DOCUMENT NO	REVISION	DATE OF REVISION
P-WGP2-076	Rev 1	12/08/2020

**mitsui** E&P  
Australia

**Waitsia Gas Project Stage 2: Response  
to Public Comments – EPA Assessment  
No. 2226**

Figure T2 Pressure monitoring of the Dongara Sandstone Formation

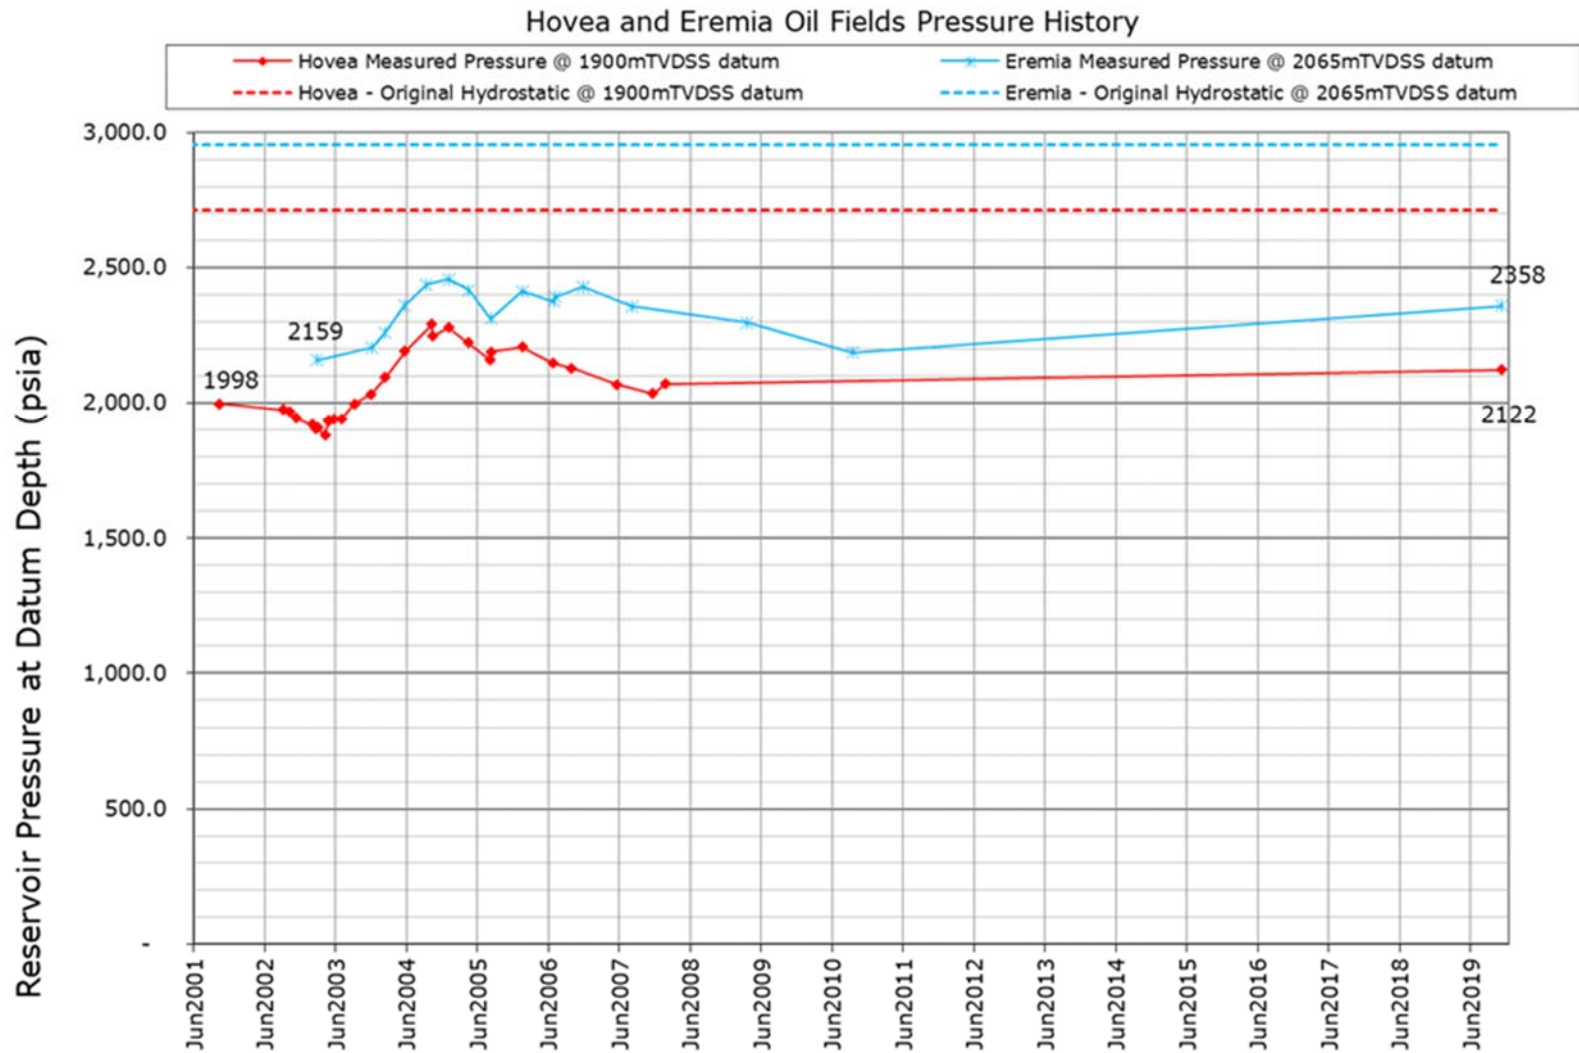
WMP 17	ANON-WNTE-47DD-H ANON-WNTE-47D4-1 ANON-WNTE-47DK-R ANON-WNTE-477Q-H	If additional wells are drilled, will this increase the estimations of formation water (currently estimated at ~1 million cubic metres of wastewater) required to be injected?	<p>Noted.</p> <p>Produced water (or formation water) is a combination of water that is condensed in the gas at reservoir conditions and formation water from the edge of the gas field. Based upon extended field appraisal, and simulation modelling of the gas field, MEPAU has estimated that there is ~7.9 bbls of formation water per MMscf of gas produced (or 44.4 m<sup>3</sup> water per million m<sup>3</sup> gas). Estimations for full field life range from 800,000 m<sup>3</sup> to 1,600,000 m<sup>3</sup>. The volume provided in the Environmental Supporting Referral Document (~1,000,000 m<sup>3</sup>) was based upon a mid (P<sub>50</sub>) estimation.</p> <p>As detailed in WMP 16, MEPAU estimates that the net volume of fluid extracted from the Dongara Sandstone Formation (accounting for the volume that was reinjected) is in the order of 80,000,000 kL (m<sup>3</sup>) indicating that there is more than sufficient capacity for further injection regardless of if additional formation water volumes are encountered.</p> <p>Monitoring undertaken by MEPAU following cessation of production from the Dongara Sandstone Formation has verified that there is sufficient capacity showing that formation pressure is well below the initial hydrostatic conditions.</p>	N/a
